Questions for Mr. Heck
A-1

Questions for Dr. Peck

In the Matter of }
CONSUMERS POWER COMPANY } Docket Nos. 50-329 OM & OL
 } 50-330 OM & OL
(Midland Plant, Units 1 and 2) }

Figure 2
(See Reference 1)

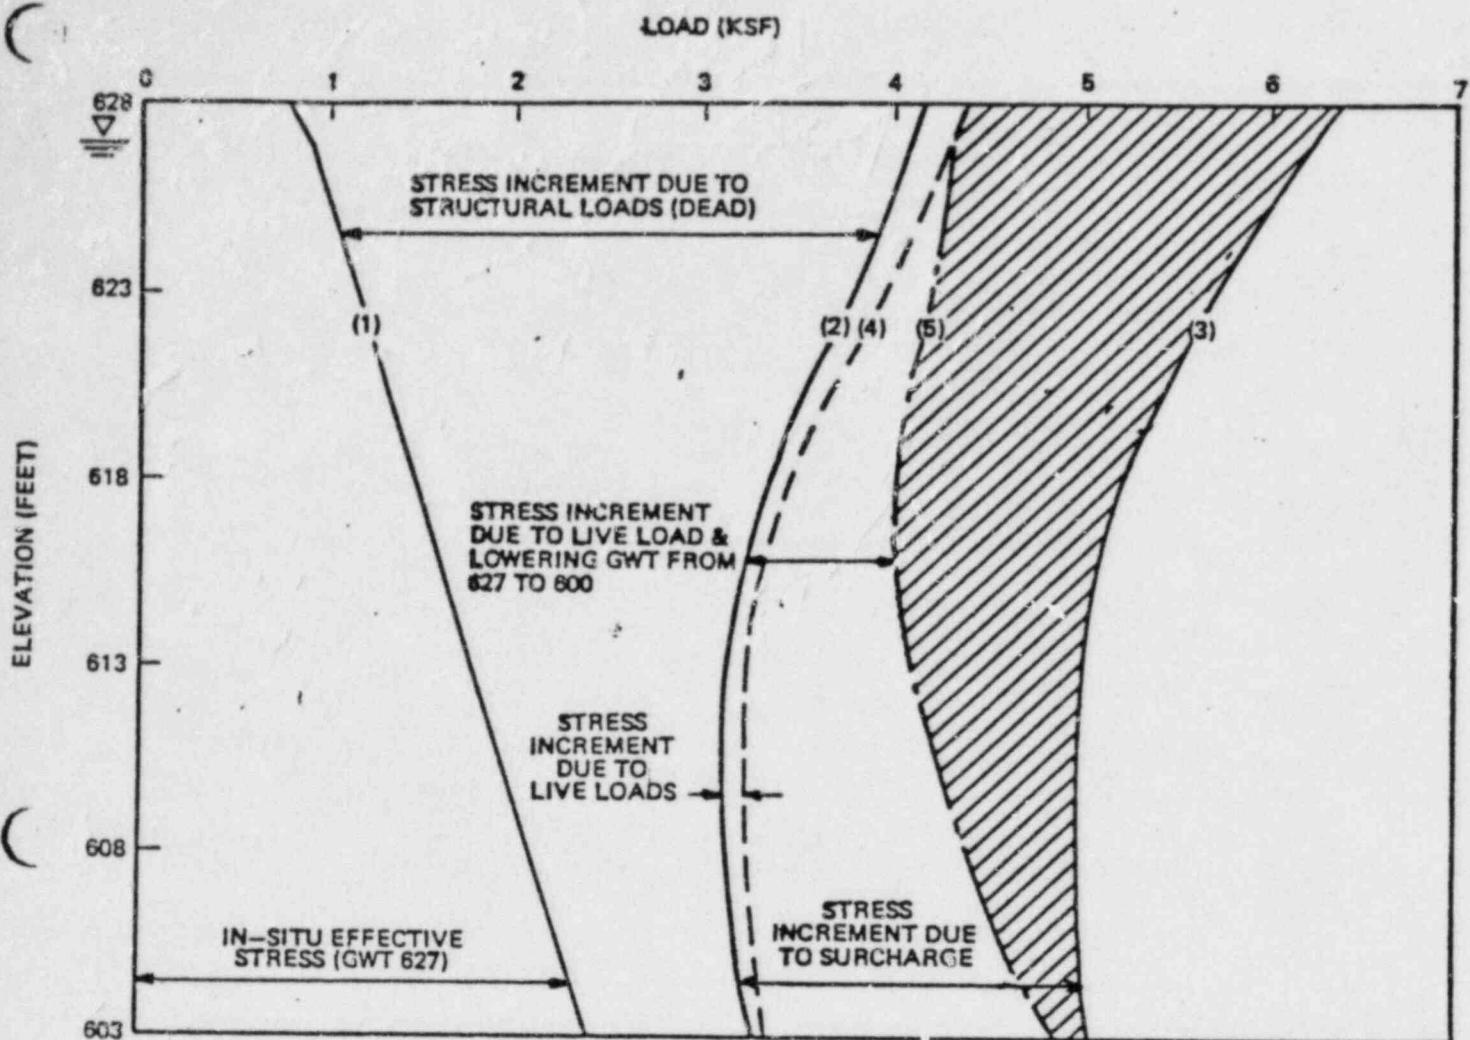
Did you compute the loading stresses which are plotted on Fig. 2? (Dr. Peck used Fig. 2 as a Vu Graph at the Aug 29, 1980 meeting in Midland)

Did you check Bechtel's computations?

Do you know the method which was used to compute the vertical stresses with depth that are reflected on Fig. 2?
Please explain how the vertical stresses with depth are computed?

On Fig. 2, what is the approximate stress increment due to structural load (dead) at Elev. 628? (Approx. 3.4 kips per sq. feet)

Was this value of 3.4 KSF your understanding of the structural loading of the DGB at the time surcharging was placed in Jan. 1979?

Can you explain for us why in Feb. 1980 the building pressure was indicated to be only 2.2 KSF? (Refer to 50.54 f volumes—responses to Q4 (Table 4-1A) ~~Q27 Pg 2228 Vol. 1~~)

What is the reason for this ~~discrepancy~~ ^{difference} in loading that existed at time of surcharge? The 2.2 KSF or the 3.4 KSF should be plotted on Fig. 2.

In your opinion which loading is the correct loading? Why?

Does this discrepancy change your opinion on the adequacy of the magnitude of the surcharge load that was imposed?

Do you know whether the stress difference between curves (2) & (4) is the FULL live load? It is not, but actually ^{25%} ~~is~~ of the full live load
Is it customary in computations for bearing capacity and settlement to use the full live load?
